**REMARKS**

Serial Number 10/822,666

ANNOTATED MARKED-UP DRAWING SHEET

FIG. 9

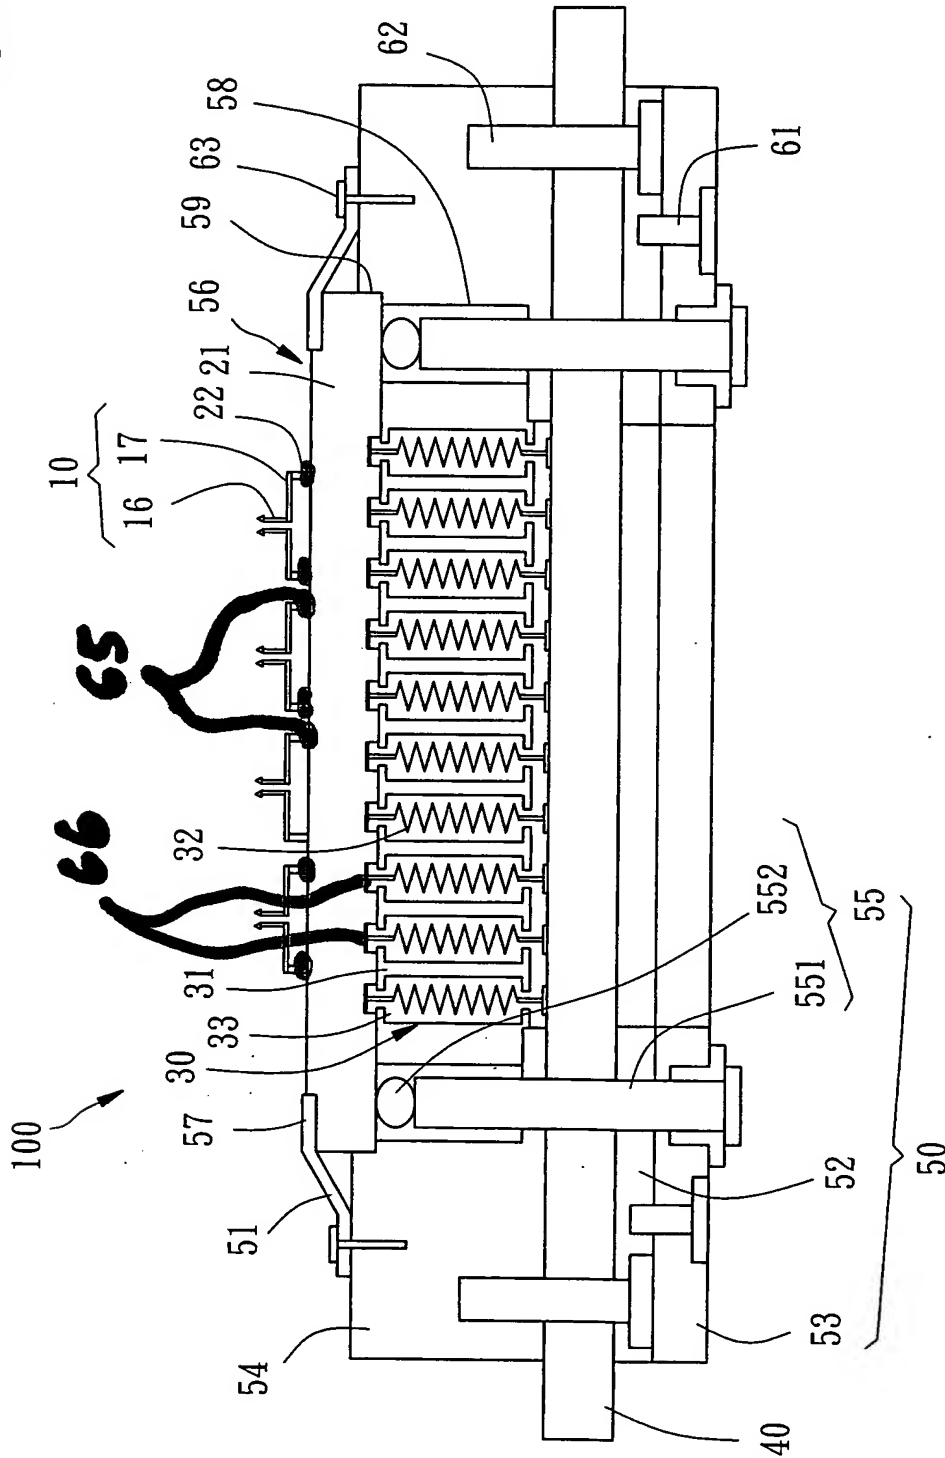
Fig. 9 has been amended to show the topside contacts described on pages 5 and 6 of the original specification, and to add reference numerals 65 and 66 to respectively indicate the **top and bottom side contacts**. Pages 5 and 6 of the specification has been amended to add reference numerals 65 and 66.

It is respectfully noted that the amendments to the drawings consist of adding lines to the bases of probe holders 22 to indicate the top side contact, and adding corresponding reference numerals. Lines 4-8 specifically describes probe holders 22 as being on the **topside contacts**, and therefore the addition of lines indicating the contacts to the drawings, and corresponding reference numerals 65 to the drawings and specification, does **not** represent **new matter**. The **bottom side contacts** are already shown, and therefore the addition of reference numerals 66 to the drawings and specification also does **not** represent **new matter**.
